RE: 3BM-COR1521 –Municipality of Coral Harbour – Renewal and Amendment Application

The Government of Nunavut Department of Community and Government Services (CGS) on behalf of the Municipality of Coral Harbour has prepared a response to the comments submitted by Environment and Climate Change Canada (ECCC) and Crown Indigenous Relations and Affairs Canada (CIRNAC) on the water license renewal and amendment application.

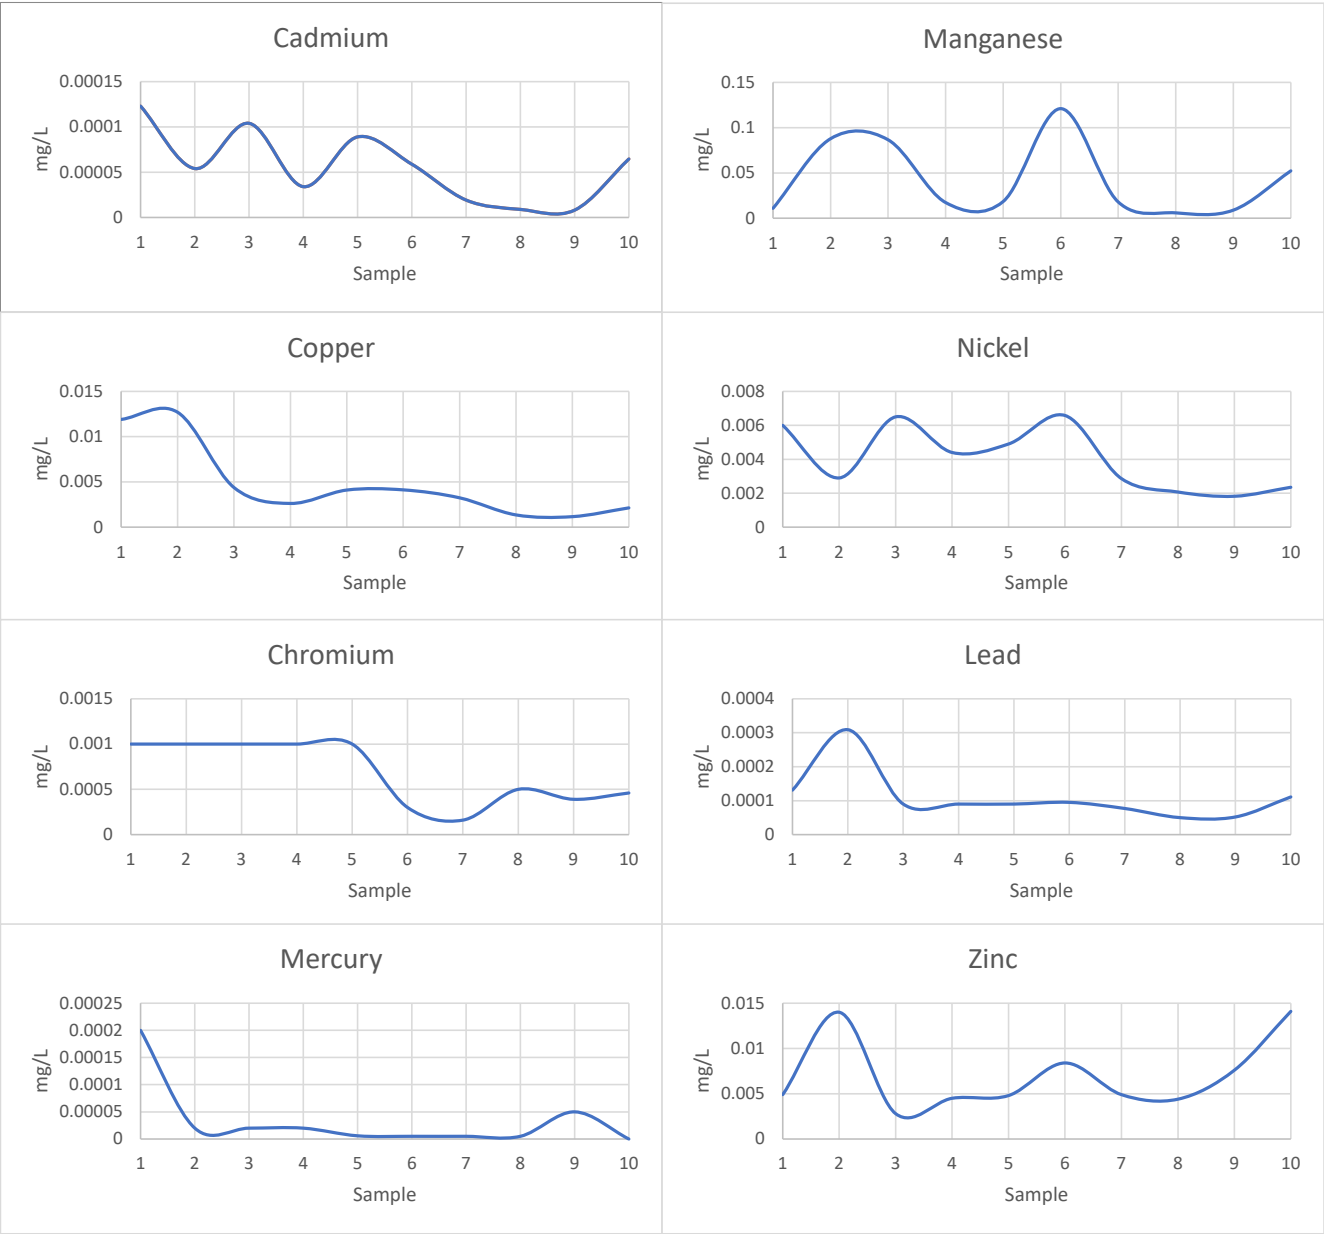
ECCC	04	ECCC recommends the Solid Waste Disposal Facilities (SWDF) drainage and Sewage Disposal Facilities (SDF) effluent be kept separate, to the extent possible, and requests the Applicant clarifies whether SWDF drainage (runoff, leachate) is able to enter the wetland treatment area. The SWDF O&M Plan should include measures to prevent the movement of SWDF runoff and leachate into the wetland treatment area.	The east berm is located at a lower elevation from the wetland channelized pathway followed by the wastewater effluent (Figure 2 in Sewage Disposal Facility OM Plan, attached below). Samples from the outlet of the wetland treatment area COR-5 are tested for metals as per the current license and the results are included in the annual reports submitted to NWB each year. If mixing is occurring upstream of COR-5 in the wetland, samples may show metal accumulation over time. The sample results from 2015-2020 are provided below along with graphs that demonstrate that there does not appear to be an increase of metals over time.

Year	Month	Sample	Cadmium	Copper	Chromium	Mercury	Manganese	Nickel	Lead	Zinc
2015	August	1	0.000123	0.0119	0.001	0.0002	0.0109	0.006	0.000131	0.0049
2016	June	2	0.000054	0.0127	0.001	0.00002	0.0878	0.0029	0.000309	0.014
2016	August	3	0.000104	0.00438	0.001	0.00002	0.0866	0.0065	0.00009	0.0028
2016	September	4	0.000034	0.00262	0.001	0.00002	0.0173	0.0044	0.00009	0.0045
2017	June	5	0.000089	0.0041	0.001	0.0000059	0.0184	0.0049	0.00009	0.0048
2017	July	6	0.0000588	0.00412	0.0003	0.000005	0.121	0.00658	0.000095	0.0084
2018	July	7	0.0000192	0.00324	0.00016	0.000005	0.0179	0.00286	0.000077	0.0049
2018	July	8	0.0000089	0.00135	0.0005	0.000005	0.0059	0.00207	0.00005	0.0044
2019	July	9	0.0000081	0.00116	0.00039	0.00005	0.00888	0.00182	0.000052	0.0076
2020	July	10	0.0000646	0.00213	0.00046	<0.000005	0.0523	0.00235	0.000111	0.0141
